**1.3 1 RAILWAY PARADE NORTH & 16 O'SULLIVAN ROAD, GLEN WAVERLEY  
CONSTRUCTION OF A FOUR (4) STOREY APARTMENT BUILDING ABOVE A  
BASEMENT CAR PARK  
(TPA/50355)**

1 Railway Parade North & 16 O'Sullivan Road, Glen Waverley - Construction Of A Four (4) Storey Apartment Building Above A Basement Car Park

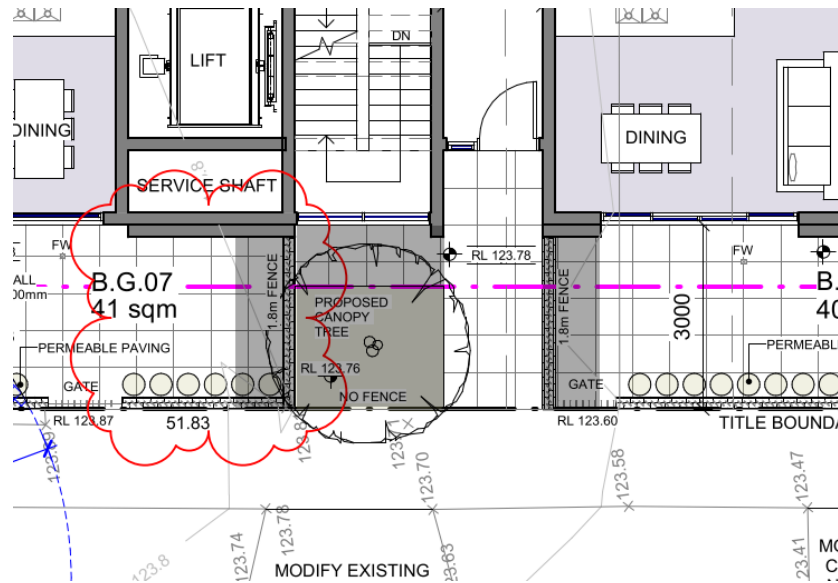
It is noted however that the planter surrounding the balcony to Unit 1 fronting the street is not shown on the landscape plan and will be required as a condition of the Permit if issued. It is also noted that the landscape plan differs from the development plan with respect to hard paving surrounding the lobby area. Given this area is not trafficable, it is considered that the development plan should be revised to be consistent with the landscape plan which shows a planter box in this location.
